FREDERICK COUNTY PLANNING COMMISSION
August 10, 2016

TITLE: **Damascus Road Community Church**

FILE NUMBER: **SP-95-40A** (AP# 16222, APFO# 16223 & FRO# 16224)

REQUEST: **Site Development Plan Approval**
The Applicant is requesting site development plan approval to eliminate previously approved buildings in Phase 2 [comprised of Phase 2a: 23,750 square foot gymnasium and Phase 2b: 29,860 square foot grand sanctuary buildings], while retaining the previously approved Phase 2 parking spaces totaling 269 spaces (106 of which are grass temporary overflow spaces).

Graphic #1: DRCC Site Aerial

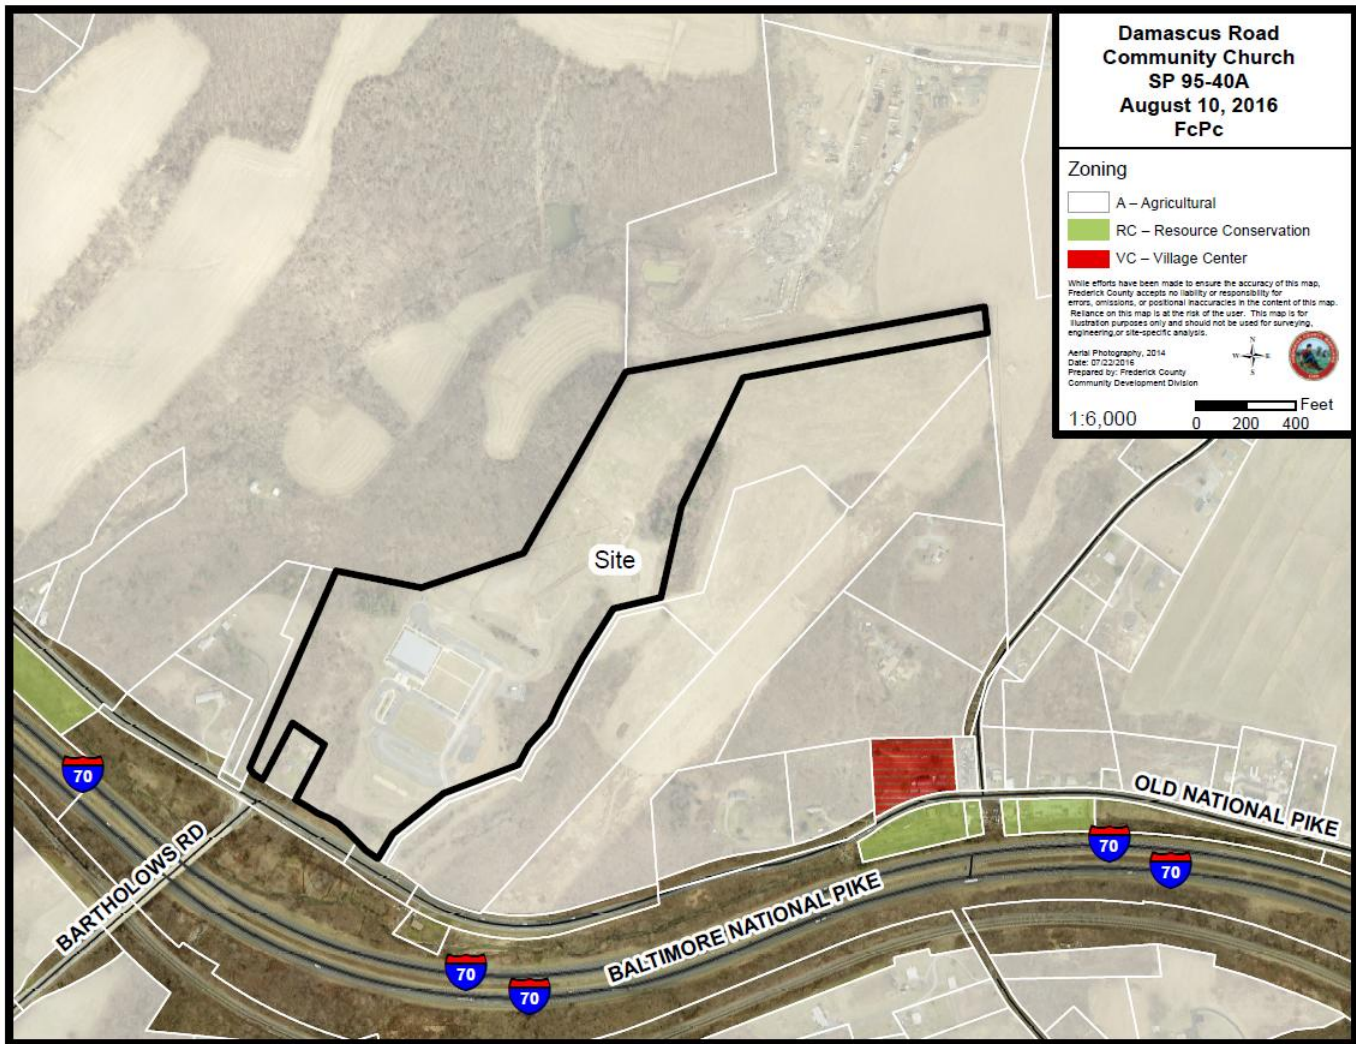
The Applicant submitted a site plan application in June 2007, requesting site plan approval for a Phase 1 Church building consisting of 22,520 square feet. The site plan was presented to the FCPC at a hearing on April 8, 2009 and was conditionally approved at that time. The structure was built, exists, and is currently utilized as the Damascus Road Community Church (DRCC), see Graphic #1.

DATE: 08/10/16
PROJECT: DAMASCUS ROAD COMMUNITY CHURCH
DRAWN BY: [Name]
CHECKED BY: [Name]

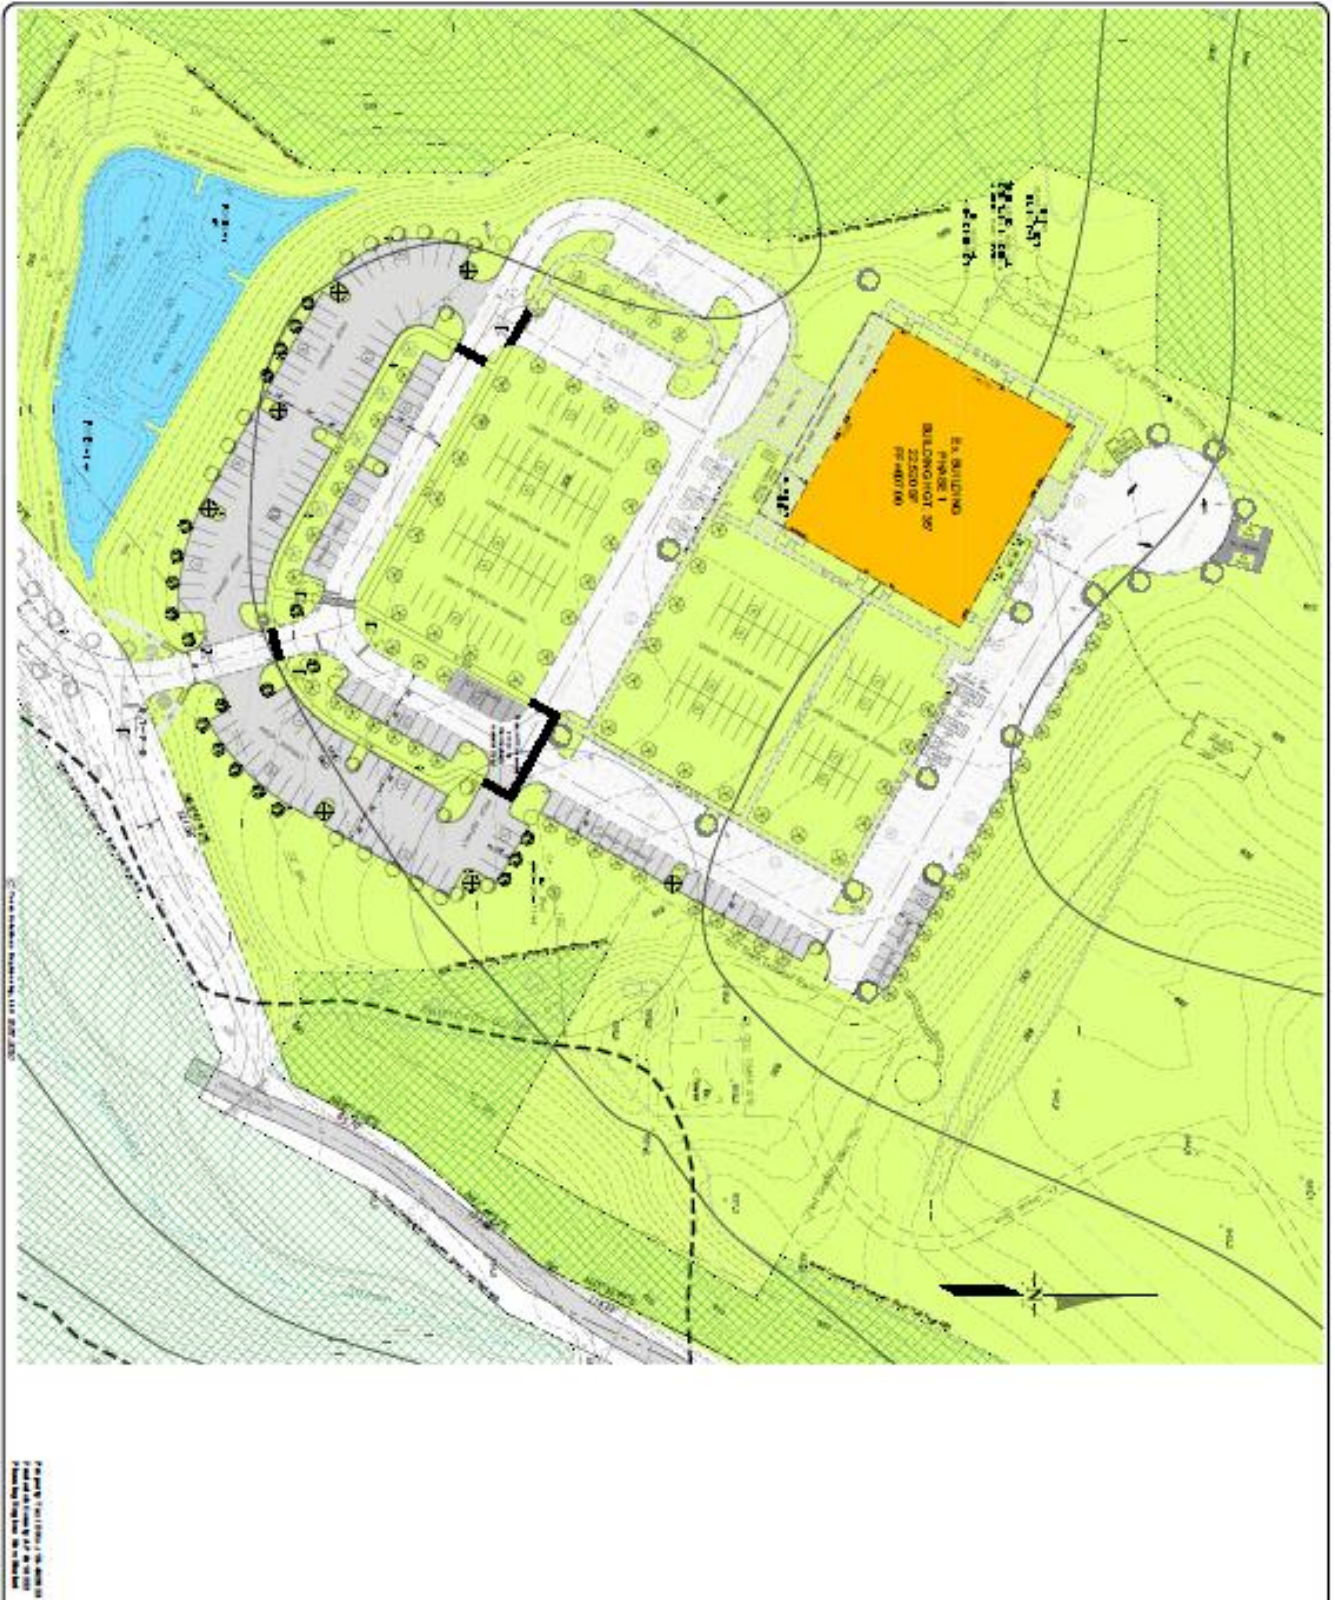
Based upon the findings and conclusions as presented in the staff report the application meets or will meet all applicable zoning, APFO, and FRO requirements once the following conditions are met:

1. Address all agency comments as the plan proceeds through to completion.
